Progress Report on Envelope Header and Bonding

Duane Remein Huawei
Glen Kramer Broadcom Limited

Figure 143-1—ONU MPRS Input Process state diagram

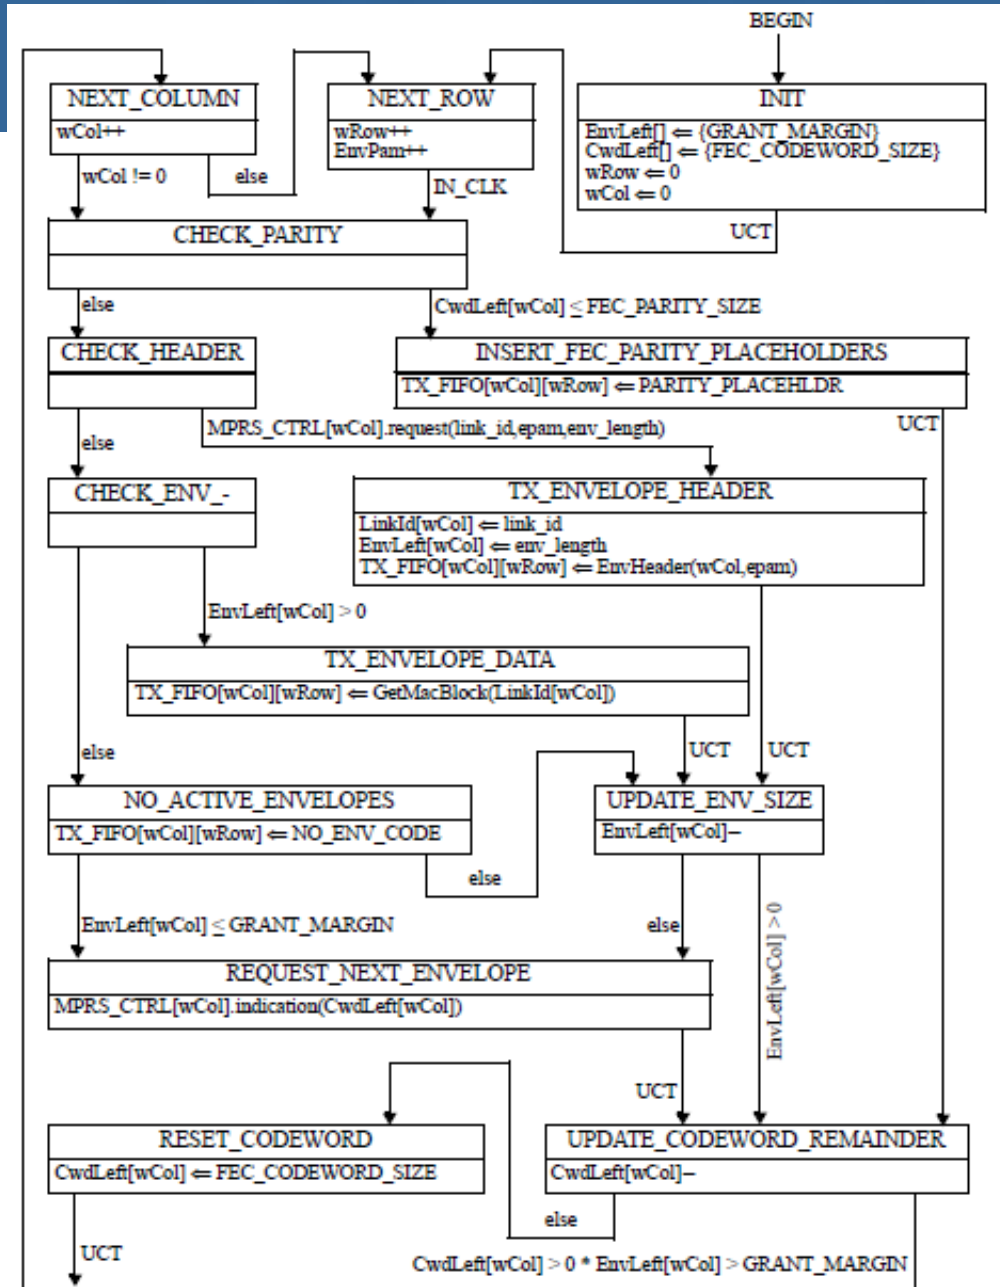
- ❑ MPCP must issue a MPRS_CTRL.request for each frame in order to achieve preamble replacement
 - Requires close coupling of MPRS and RS

Revised Input Process SD

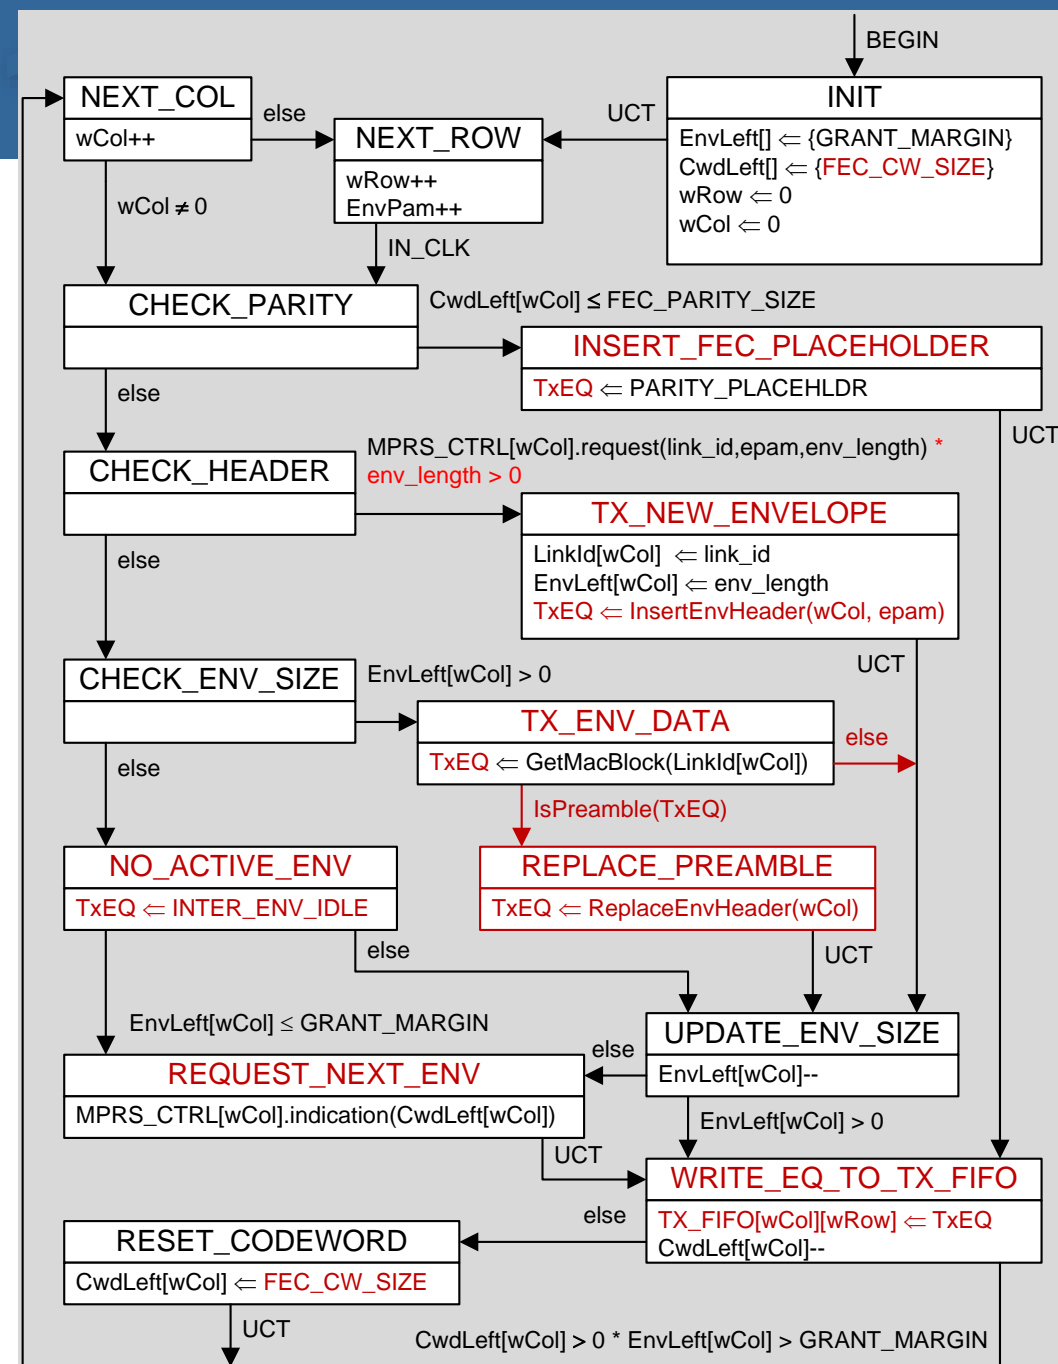
Decouples MPCP and MPRS

- MPCP can issue large Envelopes
- MPRS handles Envelope Header insertion and Preamble Replacement

❑ New State:

- REPLACE_PREAMBLE

❑ New functions:

- InsertEnvHeader(); inserts an envelope header with Preamble flag = 0
- ReplaceEnvHeader(); replaces a Preamble with an envelope header with Preamble flag = 1

❑ New variable:

- TxEQ; local variable that holds one EQ

❑ Renamed constants:

- FEC_CW_SIZE (FEC_CODEWORD_SIZE)
- INTER_ENV_IDLE (NO_ENV_CODE)

❑ Renamed States:

- INSERT_FEC_PLACEHOLDER (INSERT_FEC_PARITY_PLACEHOLDERS)
- TX_NEW_ENVELOPE (TX_ENVELOPE_HEADER)
- TX_ENV_DATA (TX_ENVELOPE_DATA)
- NO_ACTIVE_ENV (NO_ACTIVE_ENVELOPES)
- REQUEST_NEXT_ENV (REQUEST_NEXT_ENVELOPE)

❑ Changed state actions:

- TxEQ is set in various states rather than load TX_FIFO directly
- TX_FIFO is set in WRITE_EQ_TO_TX_FIFO (UPDATE_CW_REMAINDER)

Figure 143-4—OLT MPRS Output Process state diagram

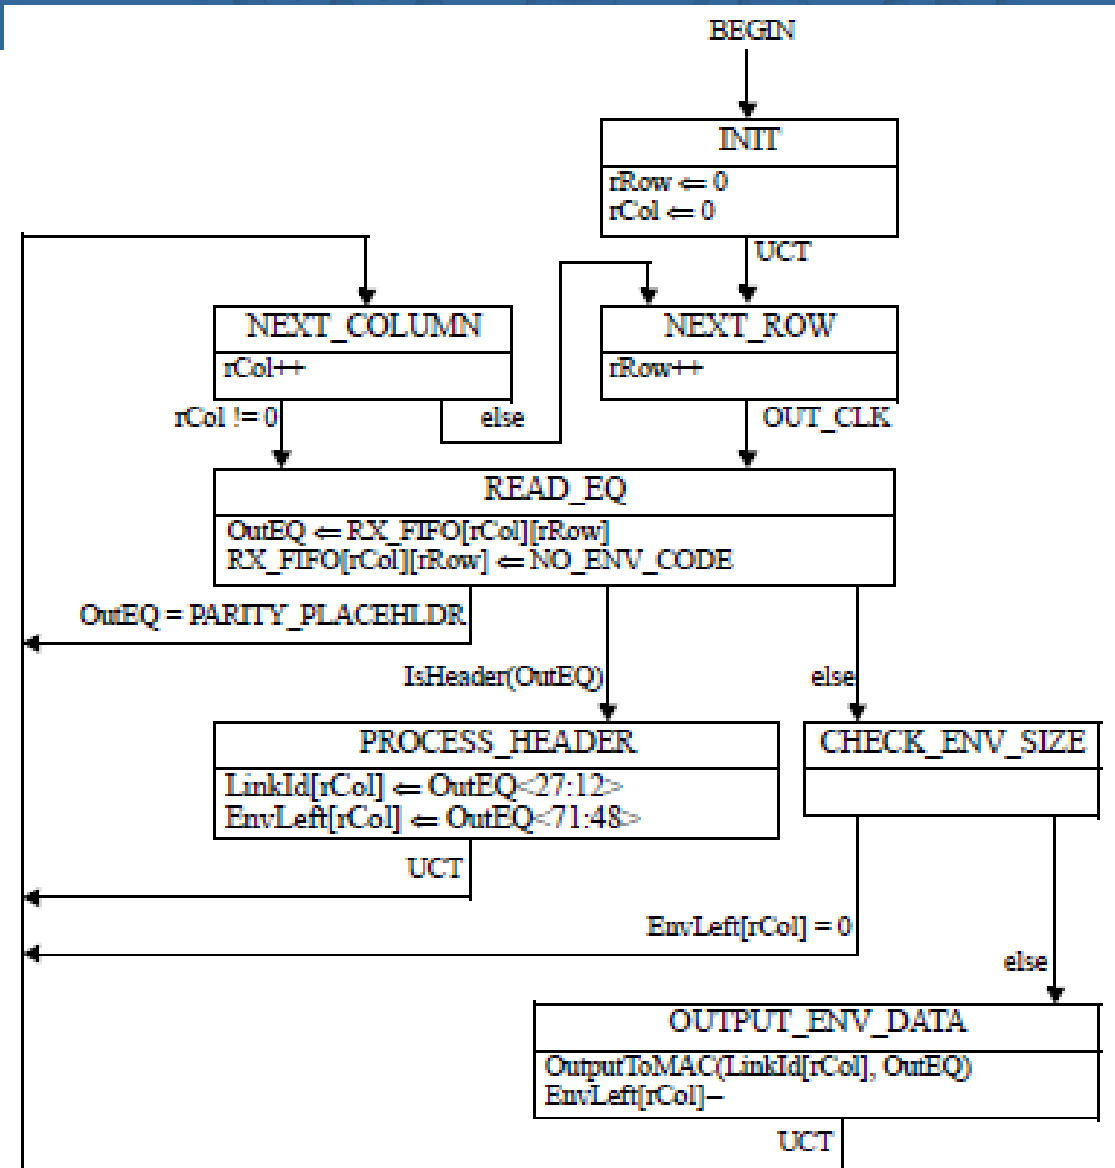
- ❑ Does not account for INTER_ENV_IDLE (was NO_ENV_CODE)
- ❑ Does not account for Preamble replacement

Revised Output Process SD

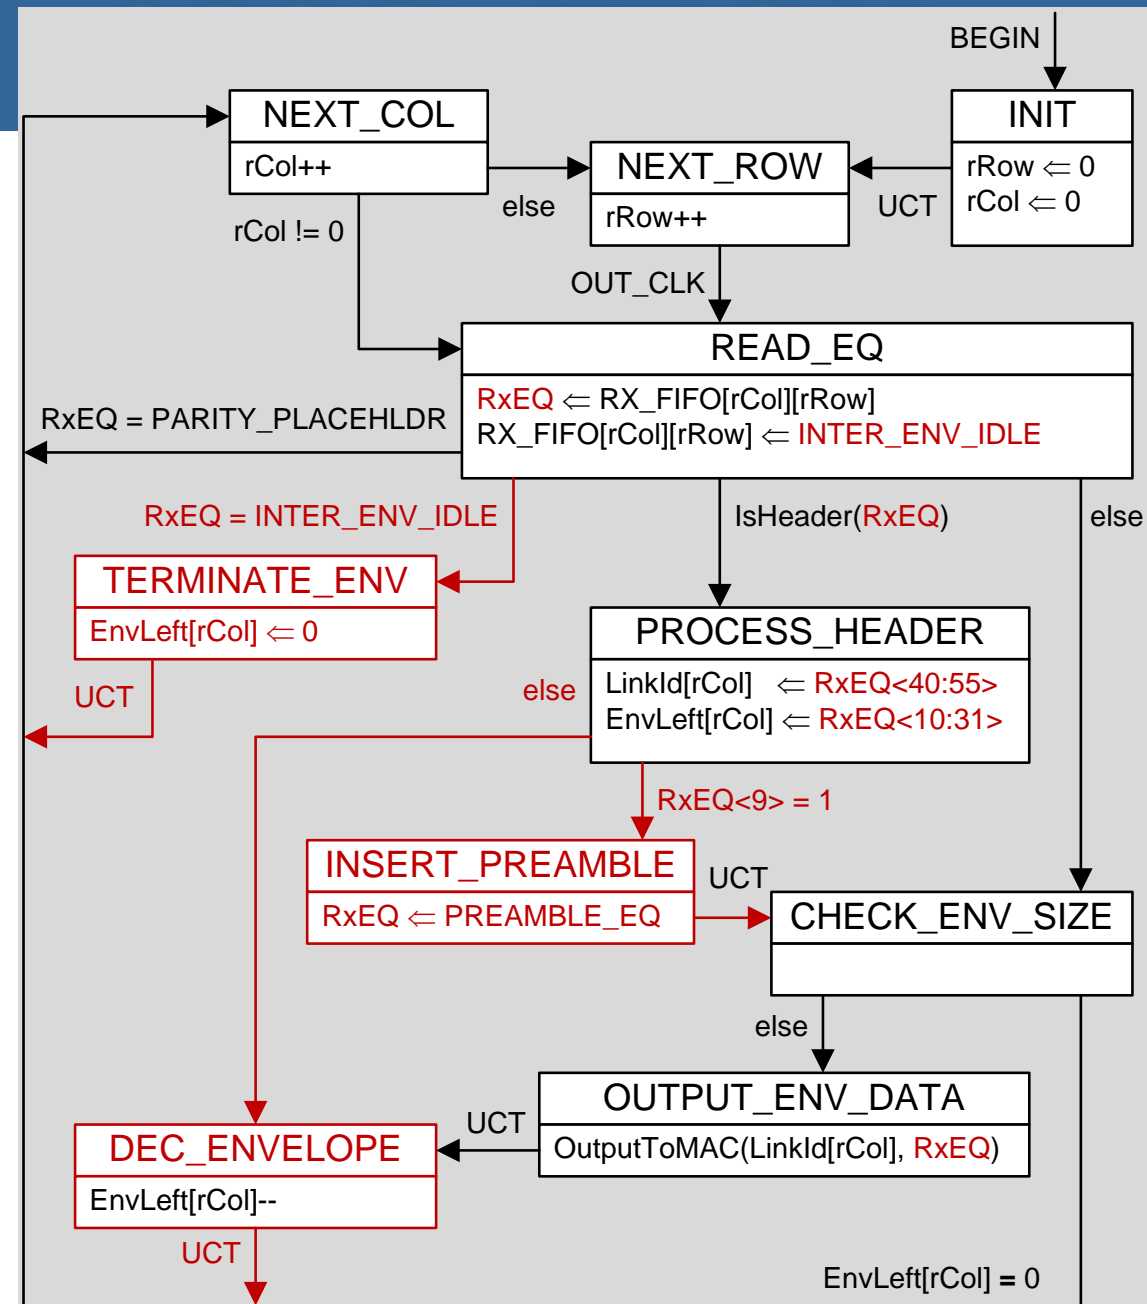
- ❑ Accommodates INTER_ENV_IDLE
- ❑ PROCESS_HEADER accommodates Preamble replacement
- ❑ EnvLeft decremented on reception of all Envelope Headers

❑ New States:

- TERMINATE_ENV; closes the current envelope when INTER_ENV_IDLE received (indicates the end of an envelope)
- INSERT_PREAMBLE; loads RxEQ with a preamble when Envelope Header is flagged as being a preamble replacement
- DEC_ENVELOPE; split "EnvLeft[rCol] -" out of OUTPUT_ENV_DATA state

❑ Renamed variable:

- RxEQ (OutEQ)

❑ New/Renamed constants:

- PREAMBLE_EQ; one EQ that is equivalent to a preamble
- INTER_ENV_IDLE (NO_ENV_CODE)

66-bit encoding of Envelope Header

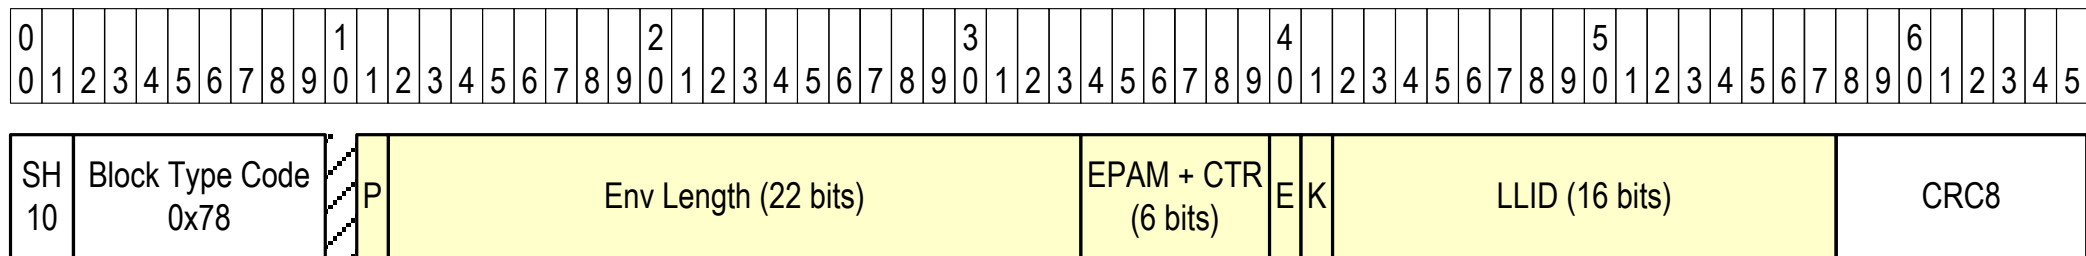
- /S/ - per Cl 49
- 1-bit reserved
- 1-bit Preamble replacement flag
- 22-bit Envelope Length (matches GATE/Grant capability)
- 2-bit reserved for DPoE style Encryption functions (reserved in 802.3ac)
- 6-bit EPAM (also functions as Encryption counter)
- 16-bit LLID
- 8-bit CRC

- The authors are continuing to work on this
 - Would like to eliminate “double header” (Envelope Header is immediately followed by Preamble Replacement when an Envelope begins with a Preamble)
 - We have some ideas on how to do this without overly complicating MPRS SDs but need to refine these ideas
